Anglia Square,
Norwich
Transport RevC Note

To: **Norwich City Council / Norfolk County Council**
From: **Iceni Projects (Transportation)**
Date: **January 2023**
Title: **Anglia Square, Norwich – Revision C Note**

3. Following on from the July 2022 Transport Assessment Addendum (RevA) submission, further amendments have been made to the proposed development as the scheme has evolved through consultation, which will be submitted as part of a Revision C submission. This note outlines the new proposals and how it compares to the previous Transport Assessment Addendum (RevA).

TITLE
 NEW BOTOLPH STREET TOUCAN CROSSING

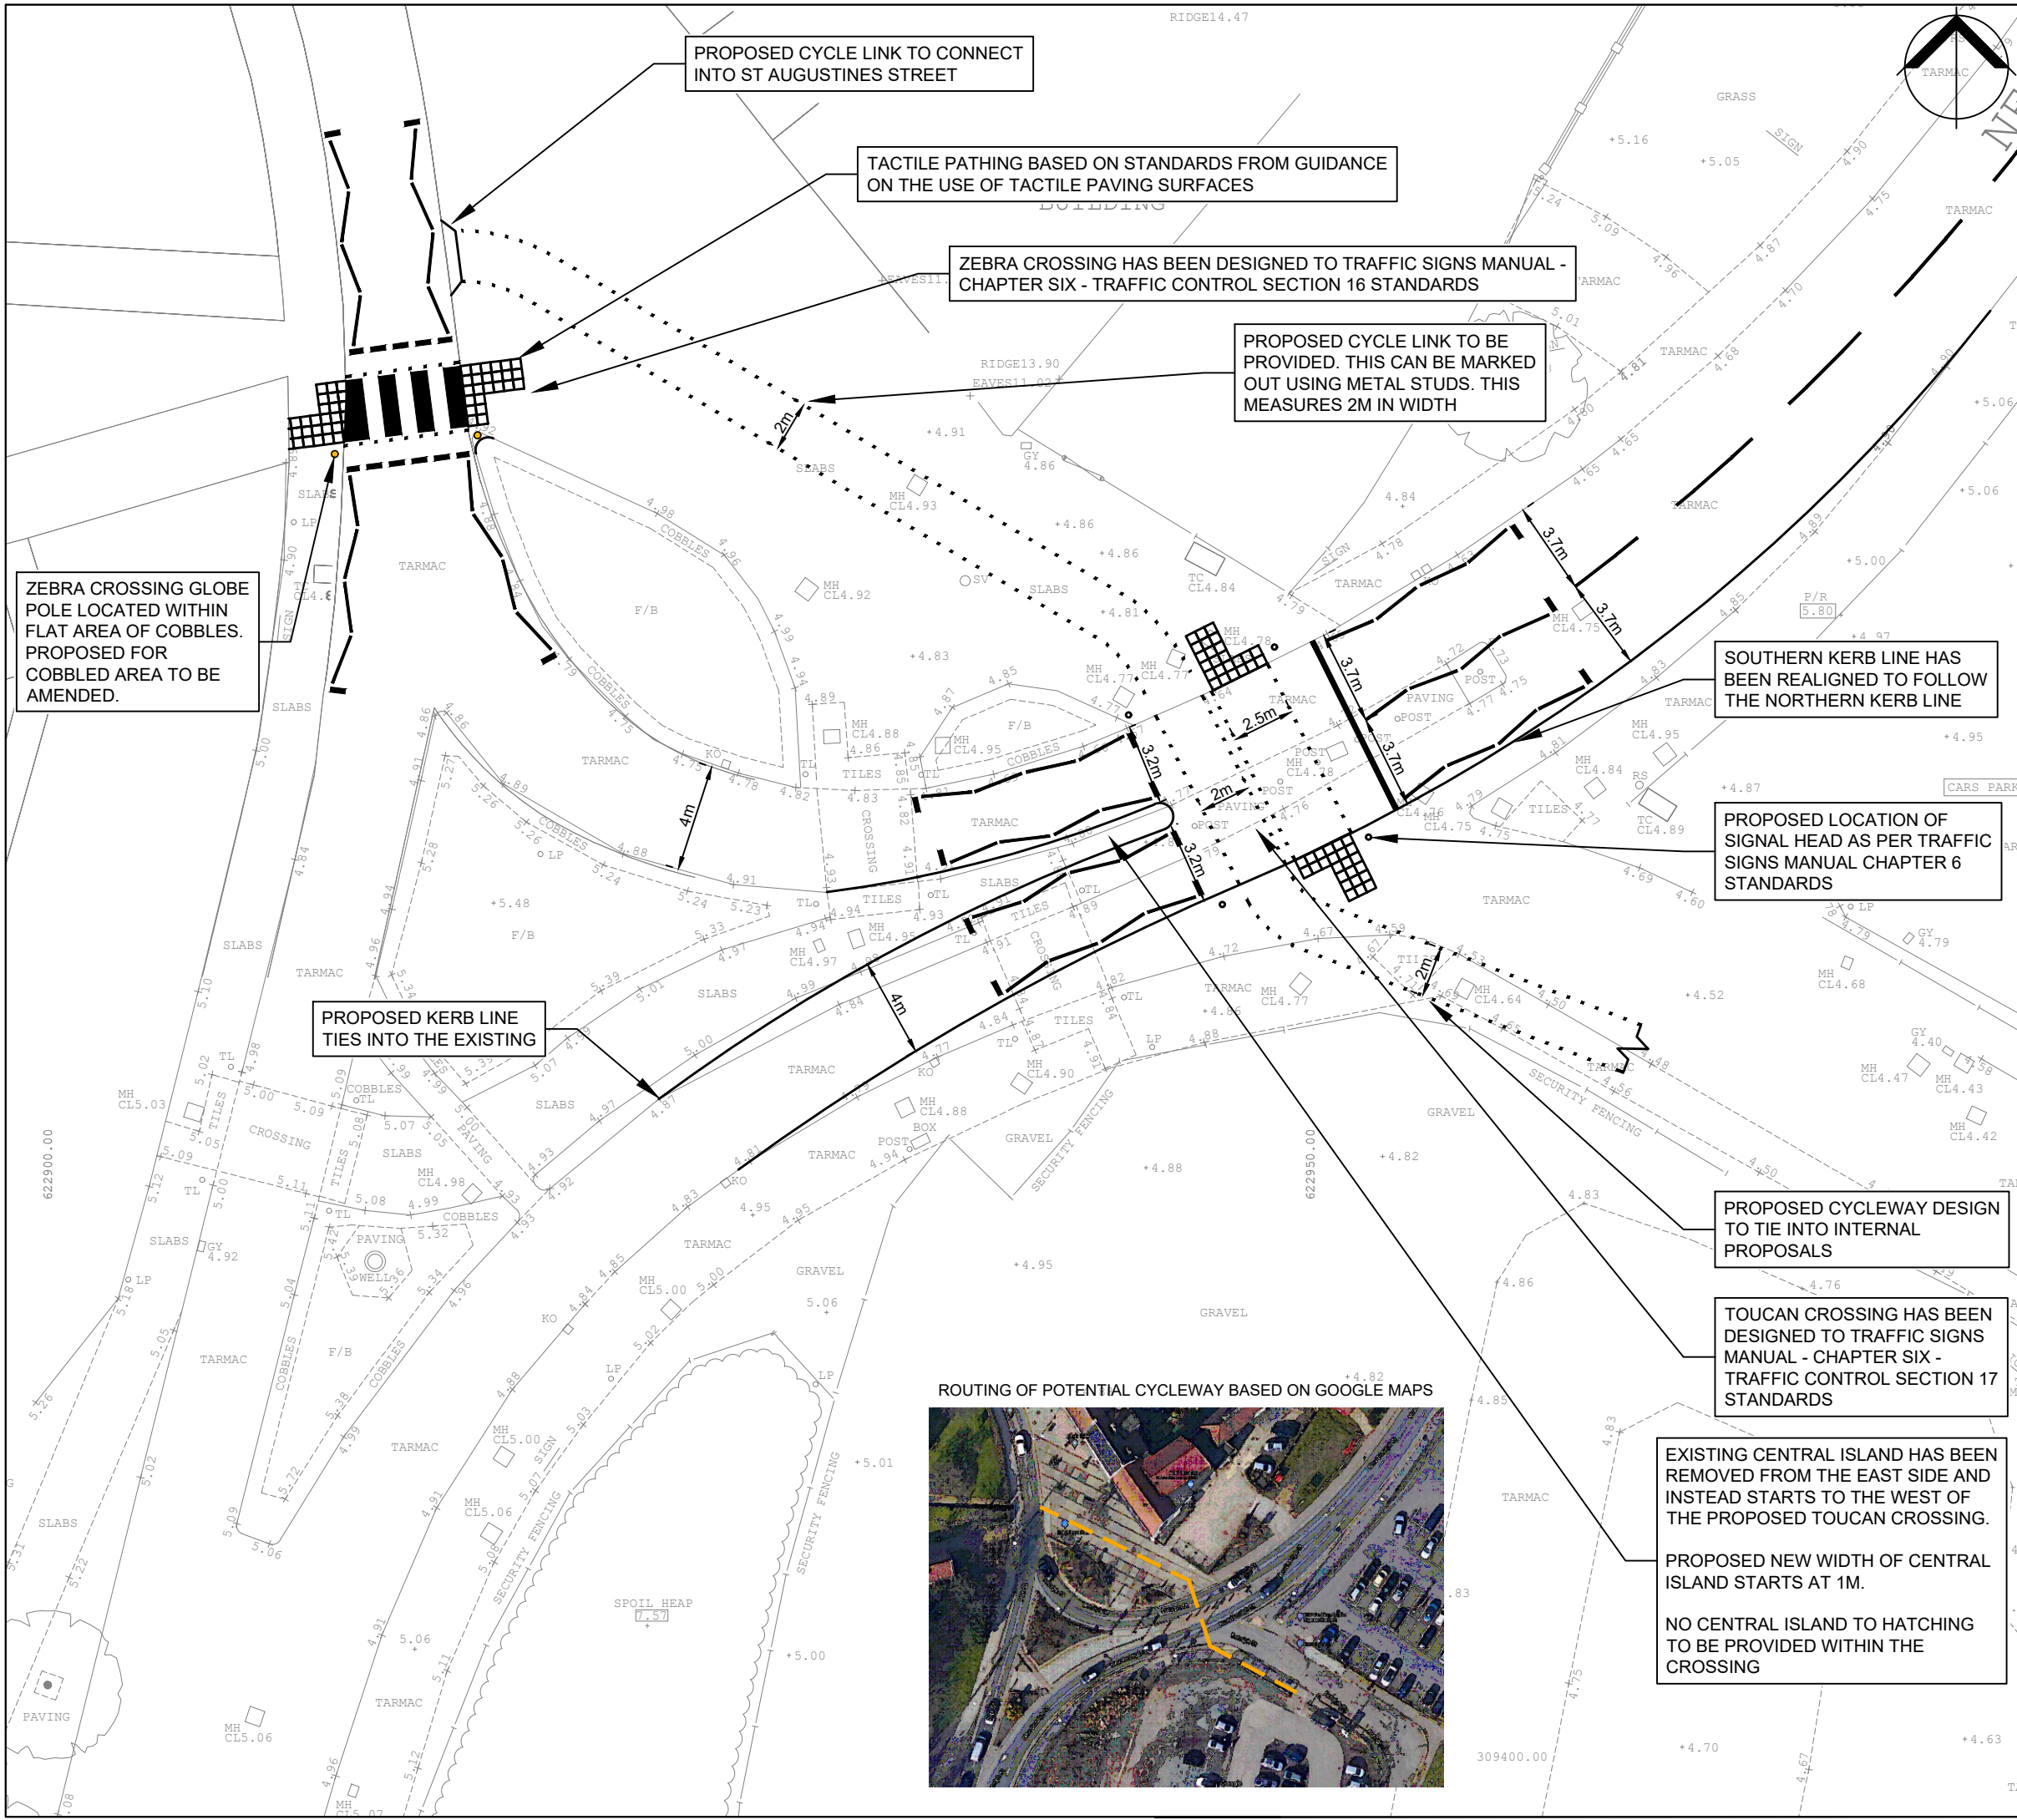
Rev.A Drawing No.	Rev.C Drawing No.	Difference Between Proposals	Comments
21-T123_37B	21-T123_37E	<p>As part of the highway works, it was agreed that a new crossing arrangement was provided across New Botolph Street to cater for the expected increased cycle and pedestrian movements in this area. This would replace the existing three signal crossings in this area by providing one toucan crossing and a zebra crossing. An initial design was sent to Norwich City Council and Norfolk County Council for review.</p> <p>Comments from Norfolk County Council suggested that the previous alignment of the splitter island and lane widths of New Botolph Street on the approach to the toucan crossing could cause issues due to the change in lane widths over a short distance. It could also give rise in their opinion to potential collisions with the splitter island. Although the splitter island had been amended, it was felt by officers that the width of the island was too large and that pedestrians could be tempted to use this area.</p> <p>The new design illustrates a realignment of the southern kerb line so that the change in width to the approach of the toucan crossing is not as severe as previously designed. The splitter island width has been reduced from 2.2m to 1m at the request of officers, which deters pedestrians using the area to stand, as well as reducing the width that pedestrians will crossing New Botolph Street.</p> <p>The 2m cycleway has been tied into the new alignment and locations of the signal heads have been shown on the plan, which demonstrates that there is sufficient space for fire tender vehicle movements</p> <p>Further discussions with Norfolk/Norwich Council highlighted that there is importance to the existing route to Gildencroft Park using the two pelican crossings on Botolph Street joined by the large central island, particularly for more vulnerable users.</p> <p>Since vulnerable road users could take longer to cross Botolph Street, the large central island facilitates access to the park.</p> <p>It was recognised that the previous design cut access to the western pelican crossing via the large central island.</p> <p>Therefore, a new zebra crossing provision has been provided to the north of the central island at the point where Botolph Street and Pitt Street connect to St Augustines Street. This re-provides the east to west connection to the park for all users.</p> <p>The planters on the central island will be extended to cover the redundant footway and cycle channel.</p>	<p>These changes are all minor amendments and are not considered as a material change to the planning application.</p>

CLIENT _____
 WESTON HOMES
 PROJECT _____
 ANGLIA SQUARE
 TITLE _____
 OVERALL VISIBILITY ASSESSMENT

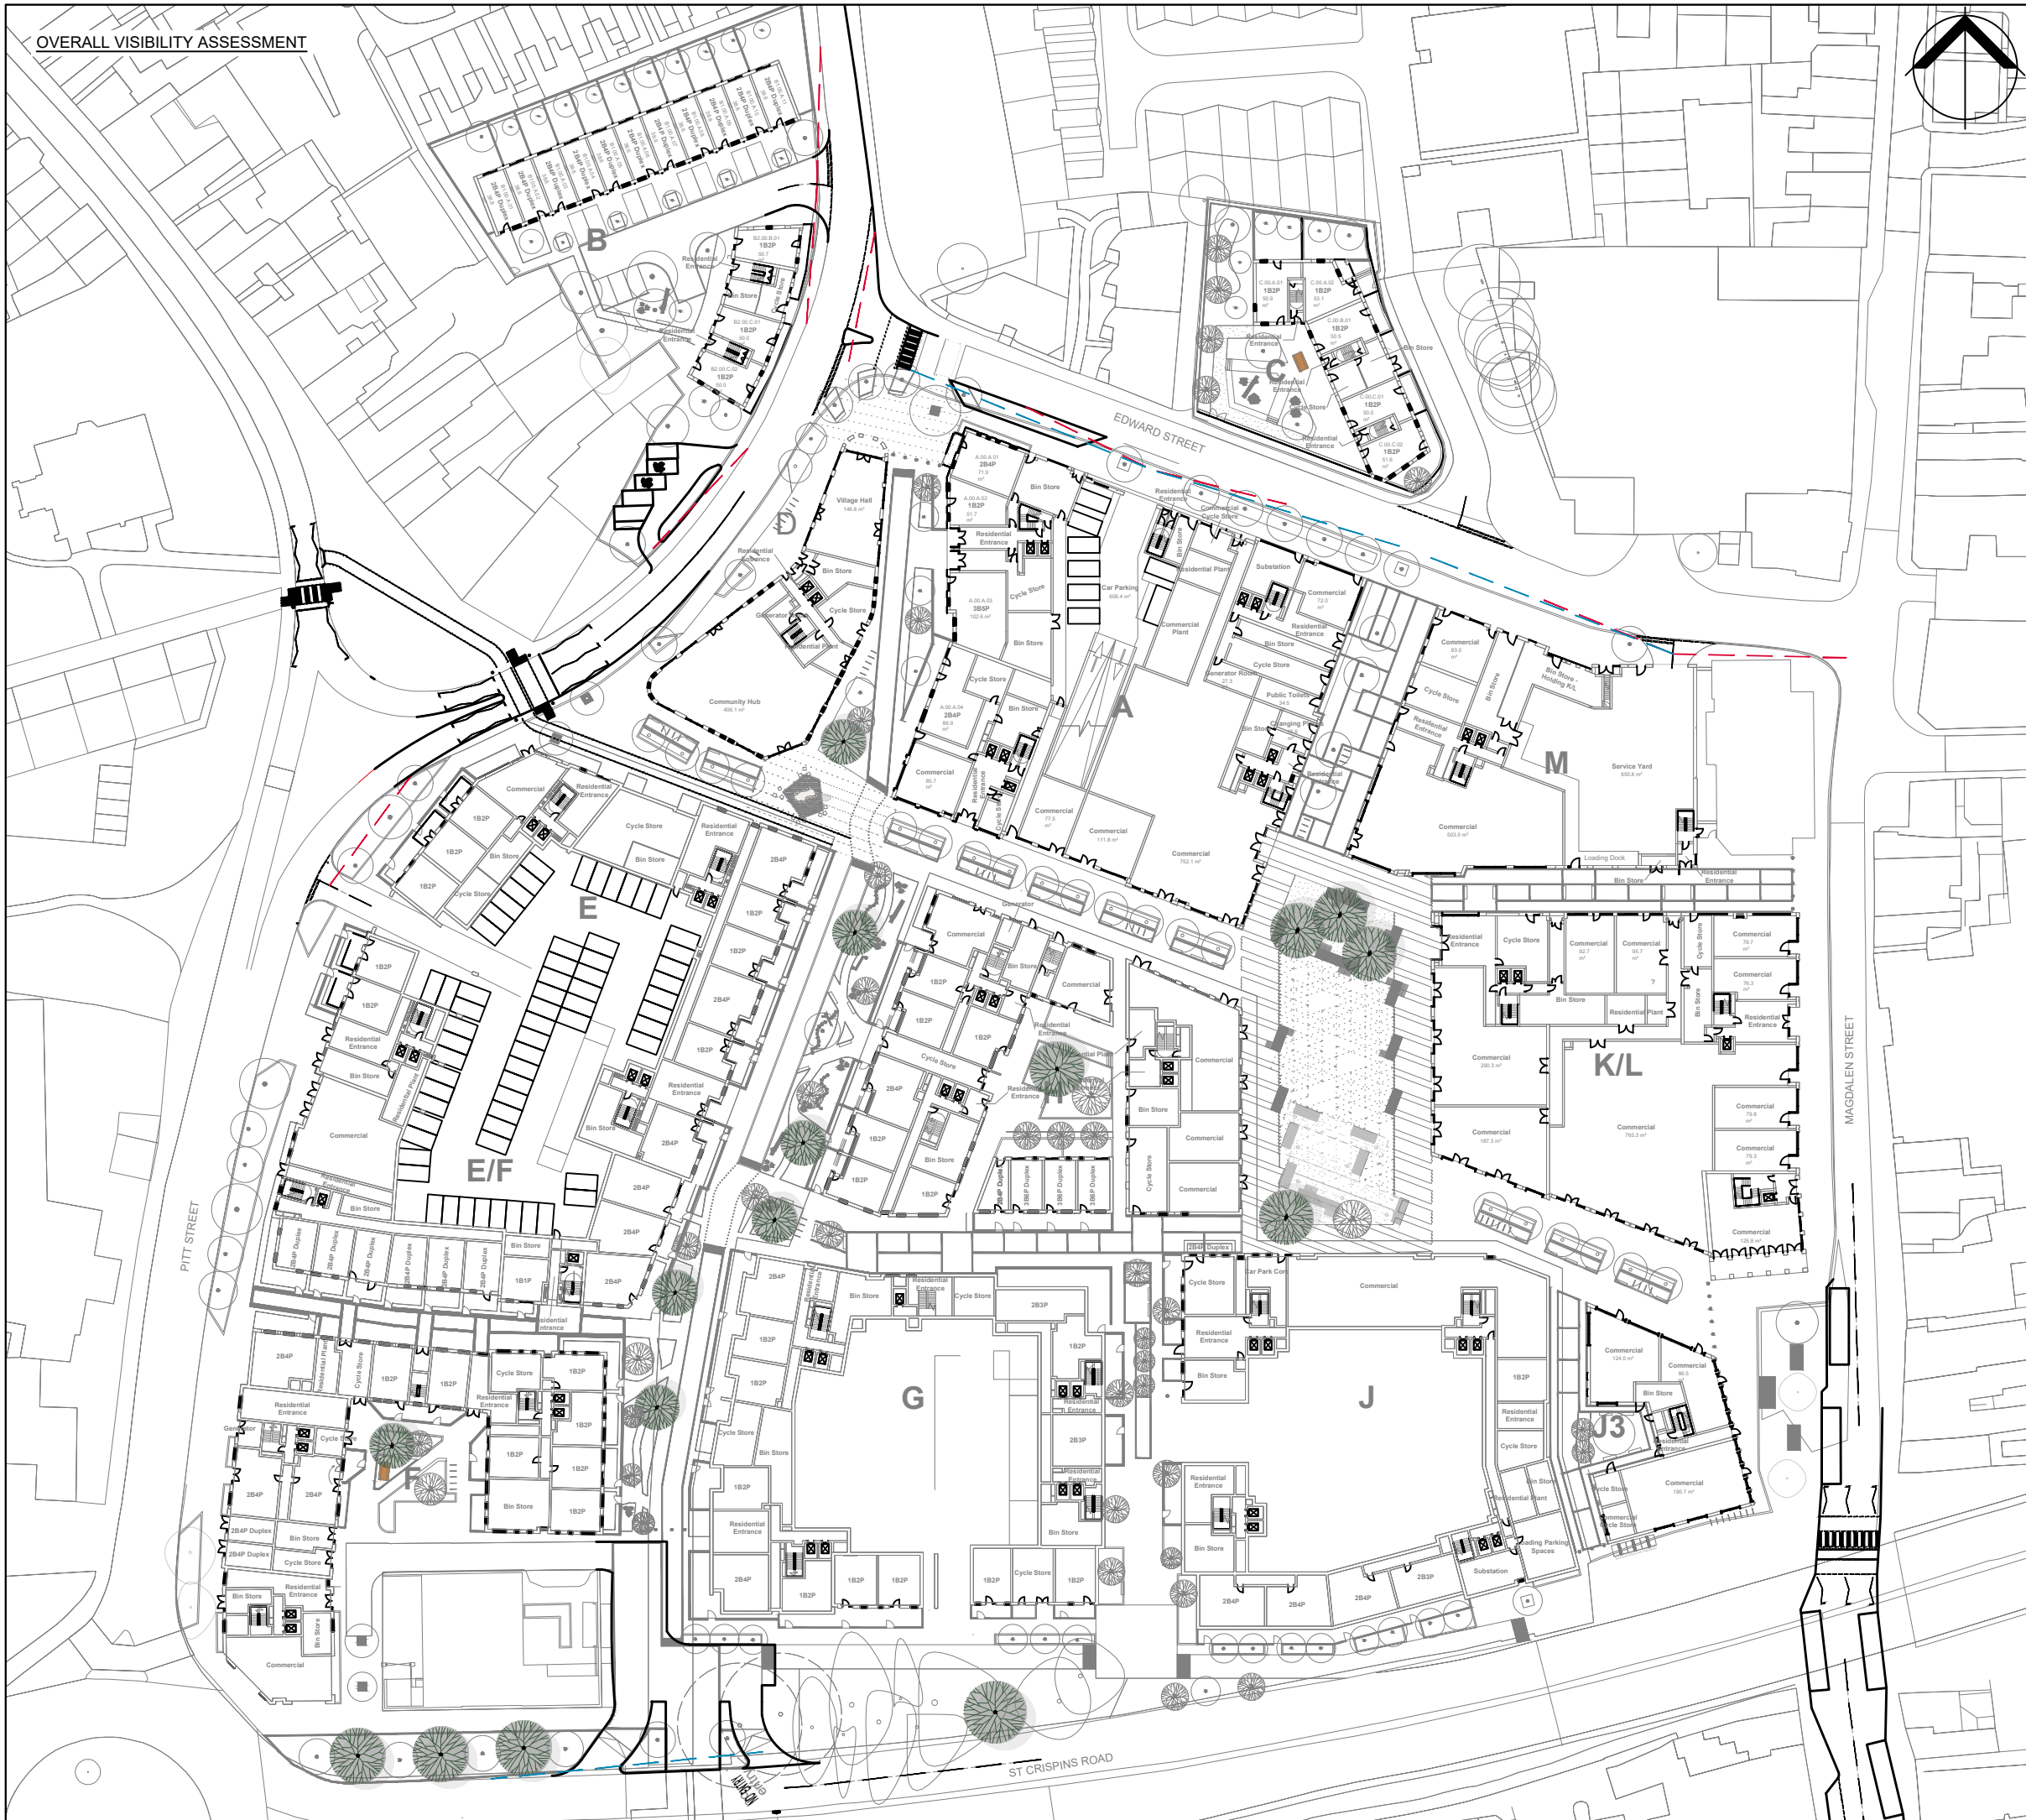
None	21-T123_42D	<p>Norfolk County Council has requested that all landscaping proposals surrounding the access arrangements are kept under a vertical height of 0.225m. This is to fully ensure that driver visibility is not obstructed when exiting from the access arrangements.</p> <p>It was also requested that any trees in front of the visibility splays should be relocated behind the splays as not to potentially obstruct driver visibility.</p> <p>Iceni Projects Ltd produced a report to outline why this restriction on vertical height is not considered standard practice and that the requirement should be increased to 0.6m. However, it was agreed that a vertical height of 0.225m would be accorded with at the request of Norfolk County Council.</p> <p>Therefore, an additional visibility splay drawing has been produced to show that no trees fall in front of the visibility splays and the landscaping strategy has been updated accordingly.</p>	These changes are all minor amendments and are not considered as a material change to the planning application.
